| Title | Enhanced contention based association | |
| Re: | The document supports a comment at Sponsor Ballot on 802.16e/D6 document | |
| Abstract | The document suggests text changes to enhance contention based association. | |

Remedy : Add the text related to Association CDMA Ranging Code.

Figure. Example of contention based association

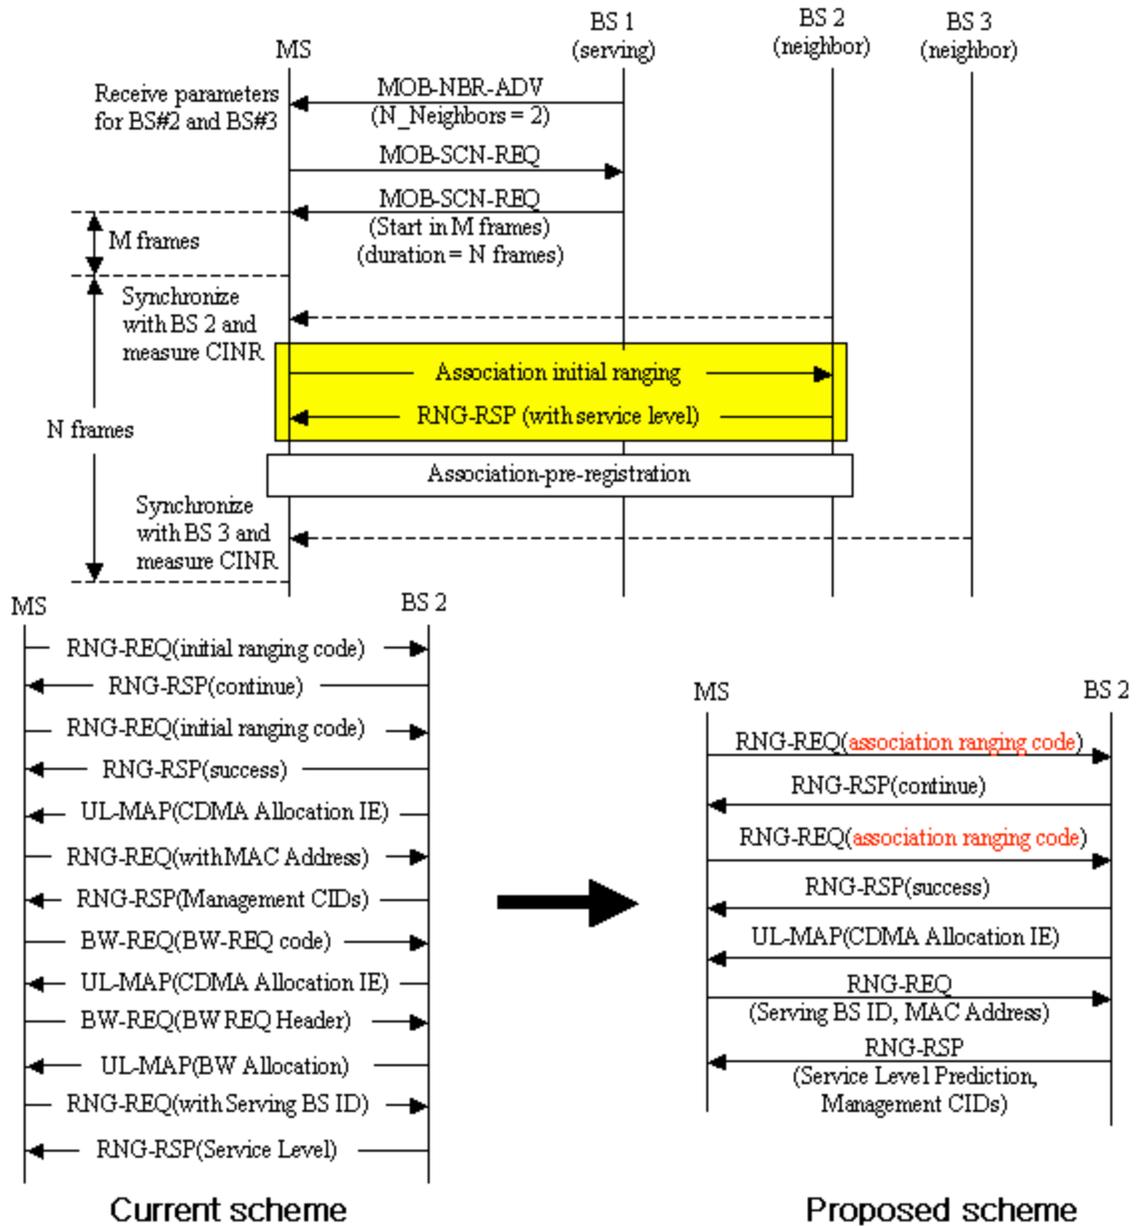
MS transmits initial ranging request for association and network entry by using initial ranging code in the UL initial ranging interval. Therefore, the BS receiving initial ranging request from the MS can not tell whether the MS is attempting network entry or association, until it receives RNG-REQ including Serving BS ID TLV.

This causes all MSs to perform the procedure for Basic/Primary management CID allocation, UL-BW Request to transmit Serving BS ID TLV, and so on. The BS can determine MSs' Service Level Prediction only after receiving Serving BS ID for the MS. If Service Level Prediction is 0 or 1, the procedure for allocation of management CIDs and bandwidth request to transmit Serving BS ID was unnecessary and caused delay for association.

If a BS differentiates initial ranging for association from network entry, it can allocate appropriate UL BW for its own purpose to the MS. This can be achieved by using ranging codes assigned only for association. Using distinctive ranging code for association makes the association procedure shorter and faster than using initial ranging code.

So, we propose Association CDMA Ranging Code to indicate initial ranging request for association.
